# Finding of Suitability to Transfer for Parcels UC-1 and UC-2

# Hunters Point Naval Shipyard San Francisco, California

#### RESPONSES TO REGULATORY AGENCY COMMENTS ON THE REVISED DRAFT FINDING OF SUITABILITY TO TRANSFER (FOST) FOR PARCELS UC-1 AND UC-2, HUNTERS POINT NAVAL SHIPYARD, SAN FRANCISCO, CALIFORNIA, DATED MAY 6, 2013

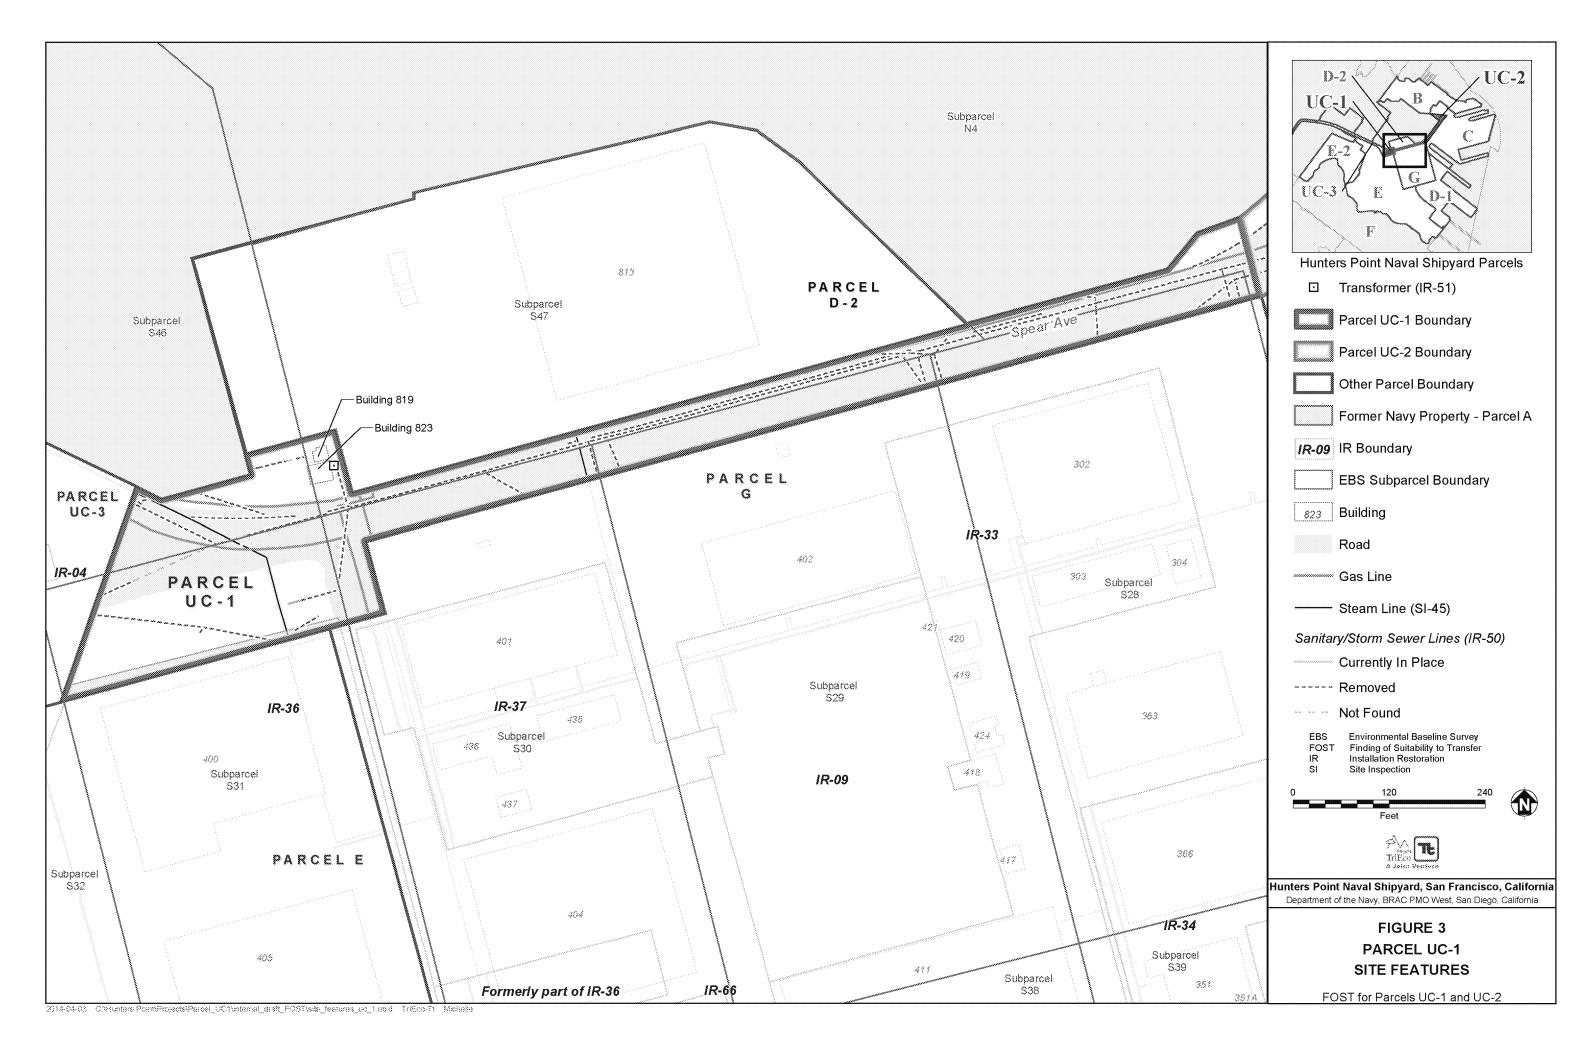
22.	Figures 4 and 5, Parcel UC-1 and Parcel UC- 2 Site Features	Please show topographic contours to denote hillsides described in the text for those not familiar with these properties.	The topography of Parcels UC-1 and UC-2 does not affect the content of the FOST and, consequently, this change has not been made.

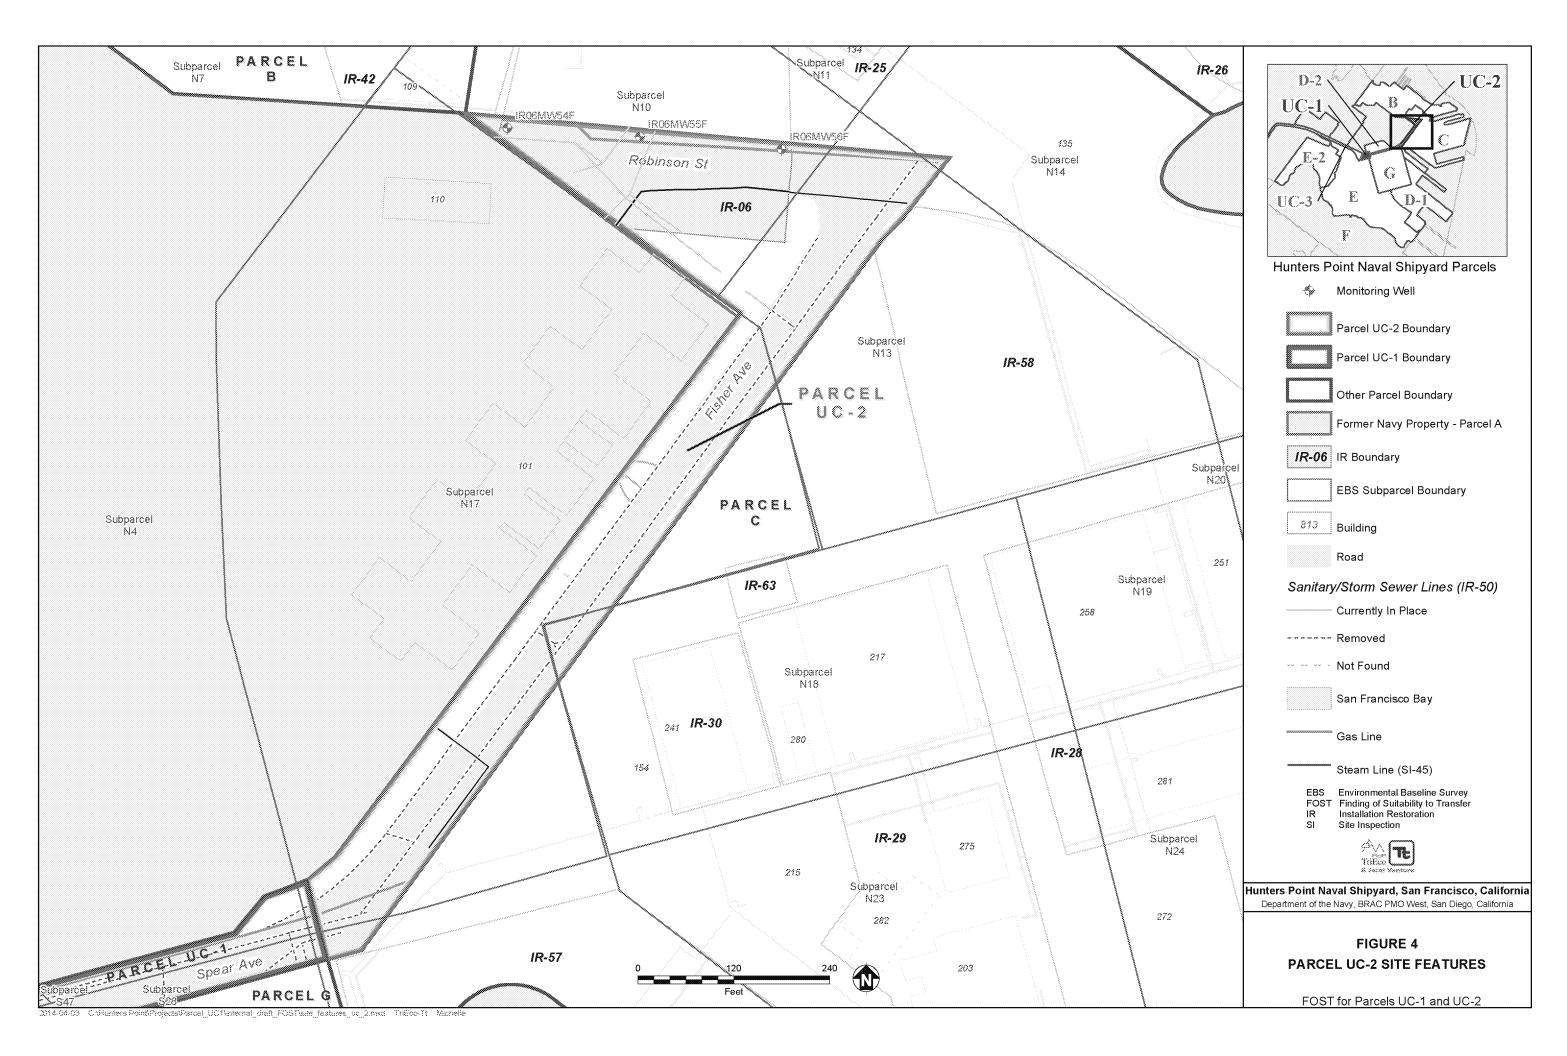
1.	Section 3.0, Table 1 - Environmental Requirements and Notifications	Environmental Requirements and Notifications. The table indicates that polychlorinated biphenyls are not applicable to the property. However, the Figure 4 map indicates that a (pole mounted) transformer was previously located east of Building 823. Please clarify when the PCB transformer was removed from the property and what investigation for any potential release(s) from the transformer was conducted. This comment also applies to Section 3.1.8 – Polychlorinated Biphenyls.	The table of environmental requirements and notifications has been revised to indicate "yes" for PCBs for Parcel UC-1. The clarification of PCB remediation and removal actions has been provided in Section 3.7 as follows:  "Since the SI was completed, the Navy has removed all transformers and oil circuit breakers associated with IR Site 51 that contained PCBs at concentrations of 5 ppm or more. The only transformer at the Property was a pole-mounted transformer designated Substation I-4. The pole-mounted transformer (Substation I-4) at Building 819 was removed from the property and disposed of off site (Tetra Tech EM Inc. 1998). The evaluation of the area around the transformer did not indicate the need for any further investigation."

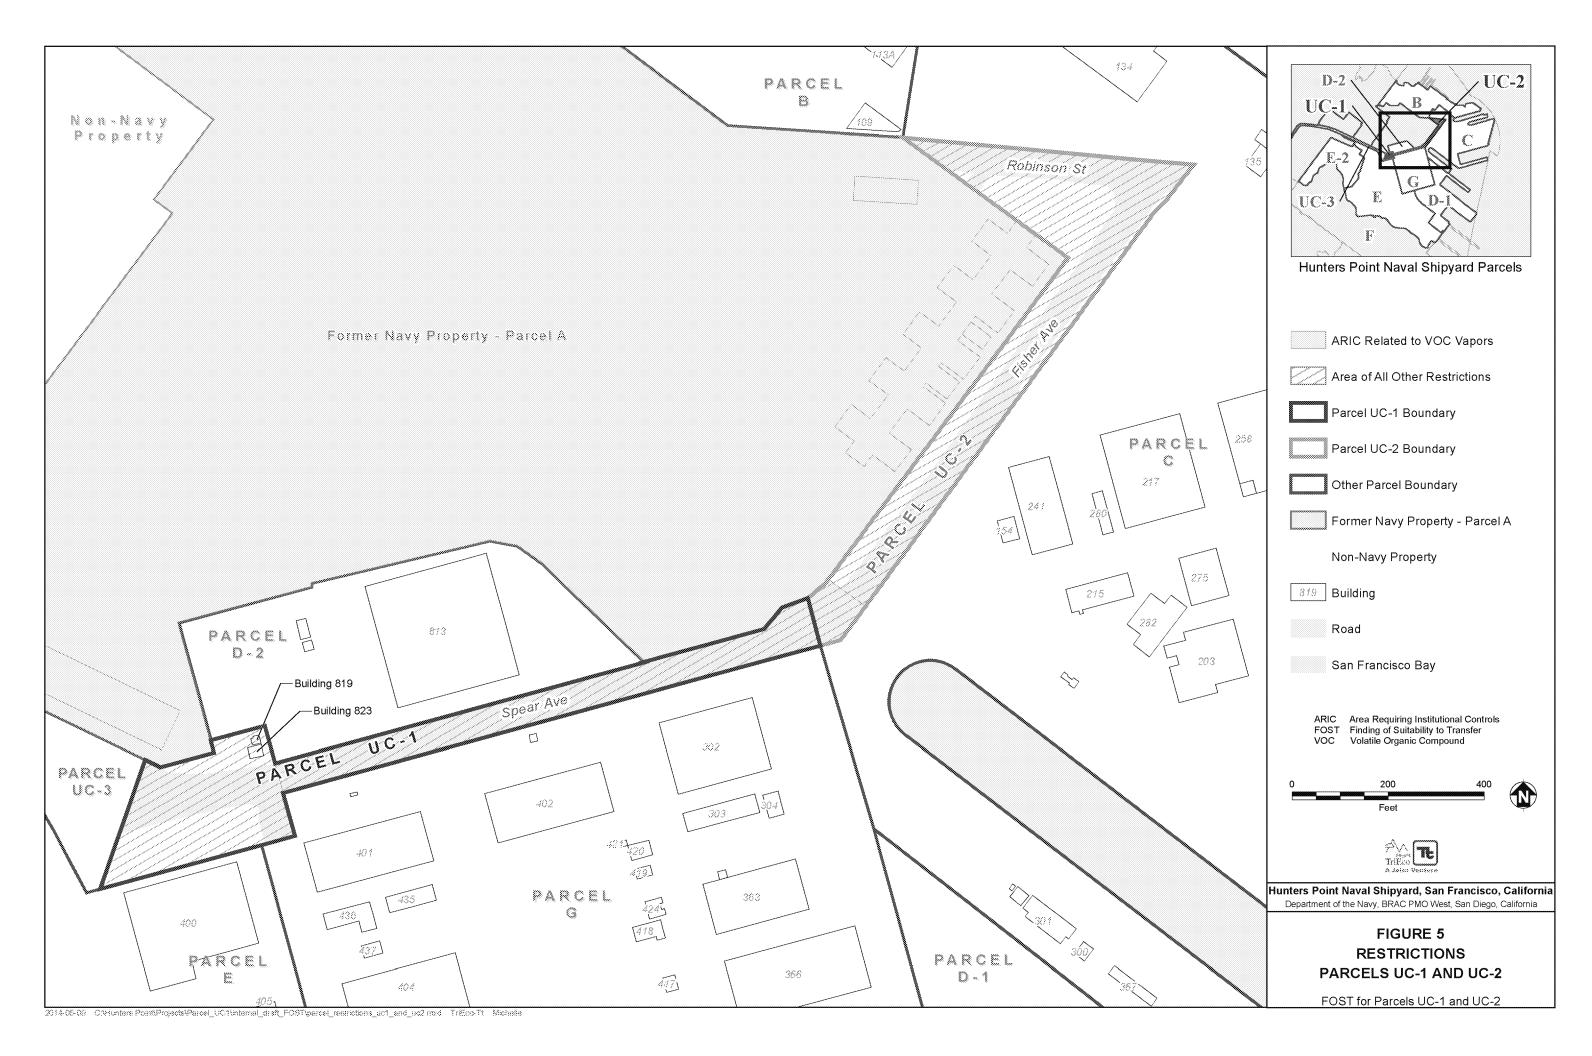
Comment Number	Section/Page	Comment	Response to Comment
Responses	to Comments from S	an Francisco Regional Water Quality C	ontrol Board (Ross Steenson, dated June 4, 2013)
Specific Co	mments		
la.	Section 3.1.1, IR Site 6, Page 3 and Figure 5	Parcel UC-1 – Provide clarification regarding the timing of a soil vapor survey for Parcel UC-1 and Vapor Intrusion ARIC determination relative to the finalization of the FOST. The July 24, 2009 Final Record of Decision for Parcels D-1 and UC-1 states (p. 46) that soil vapor surveys will be conducted for several purposes, including identification of the Vapor Intrusion ARIC. Since a soil vapor survey has not been performed for Parcel UC-1, moving forward with the FOST appears premature.	The Navy completed a soil vapor investigation at Parcel UC-1 in October 2013 (ERRG 2014). The FOST has been revised to incorporate the results of this investigation.

Comment Number	Section/Page	Comment	Response to Comment
1b.	Section 3.1.1, IR Site 6, Page 3 and Figure 5	Parcel UC-2 – Revise the Vapor Intrusion ARIC for Parcel UC-2 to reflect the findings (Figure 8-5) in the March 2013 Final Technical Memorandum – Soil Vapor Investigation in Support of Vapor Intrusion Assessment, Parcels B, D-1, G, and UC-2. The Vapor Intrusion ARIC in the northeast portion of the parcel, as show on Figure 5, is no longer necessary. A Vapor Intrusion ARIC is necessary for the southeast portion of Parcel UC-2.	Figure 5 has been revised to show the ARICs for VOC vapors as currently envisioned based on the results of the soil gas surveys.

Comment Number Section/Pag	e Comment	Response to Comment
5. Section 6.0 Restrictions ARIC for VO Vapors and Figure 5	VOCs and refers to Figure 5 (see comments below pertaining to problems with Figure 5). On	"Construction of enclosed structures. Risk to human health may exist from potential intrusion of VOC vapors into structures built at portions of the Property. Consequently, these areas are included in the ARICs for VOC vapors (see Figure 5). Prior to construction of any new enclosed structure within a VOC ARIC, the Owner shall obtain approval from the FFA signatories of the vapor mitigation engineering controls or design alternatives to be incorporated in that structure. A reduction in potential risk can be achieved through engineering controls or other design alternatives that meet the specifications that will be set forth in the remedial action work plan. The specifications will include, but will not be limited to, DTSC's "Final Guidance for the Evaluation and Mitigation of Subsurface Vapor Intrusion to Indoor Air, Interim Final" and "Final Vapor Intrusion Mitigation Advisory, Revision 1," both dated October 2011 (DTSC 2011b, 2011c) December 15, 2004, and revised on February 7, 2005.  [response continues below]

Comment Number	Section/Page	Comment	Response to Comment
6.	UC-1, Soil Vapor and Figure 5	The Parcel UC-1 ROD lists the following actions (page 46 of the ROD) that have not been implemented on Parcel UC-1. Please address this issue and document in the appropriate location (FOST, RACR, ?):	The Navy completed a soil vapor investigation at Parcel UC-1 in October 2013 (ERRG 2014). The FOST has been revised to incorporate the results of this investigation. Figure 5 has been revised to show the ARICs for VOC vapors as currently envisioned
		Soil vapor surveys will be conducted for the following purposes:	based on the results of the soil gas survey.

• To identify where the initial areas requiring institutional controls (ARIC) for VOCs would be retained and where they would be released, and	
		• To evaluate the need for additional remedial action in order to remove ARICs.	
		Assuming that this work is completed prior to finalization of the FOST, please revise Figure 5 to incorporate the results of the soil vapor survey and (presumably) reduce the size of the VOC ARIC on Parcel UC-1 rather than showing the entire UC-1 parcel with yellow hatching.

Comment Number	Section/Page	Comment	Response to Comment
7.	Figure 5 and UC-2	We are confused by the designation of the ARIC for VOC vapors illustrated on Figure 5 in UC-2. It is significantly different than the configuration illustrated in the Figure 8-5 TIER 2 HHRA RESIDENTIAL EXPOSURE CANCER RISK ESTIMATES FROM VAPOR INTRUSION EVALUATION OF VOCs PARCEL UC-2 from the FINAL TECHNICAL MEMORANDUM SOIL VAPOR INVESTIGATION IN SUPPORT OF VAPOR INTRUSION ASSESSMENT PARCELS B, D-1, G and UC-2 dated March 2013. Isn't Figure 5 supposed to match this Figure 8-5 and show only the one acre grid in the southwest corner of UC-2 as being covered by the ARIC for VOC vapors? In what document is this designated yellow hatched area along the northeast edge of UC-2 defined? We believe that only the area shown in Figure 8-5 is the designated ARIC for VOC vapors because the ROD groundwater remedial goals related to vapor intrusion risk have been superseded by this March 2013 document (see comment 1 above).	Please see the response to city comment 1 above. Figure 5 has been revised to show the ARICs for VOC vapors as currently envisioned based on the results of the soil gas surveys.
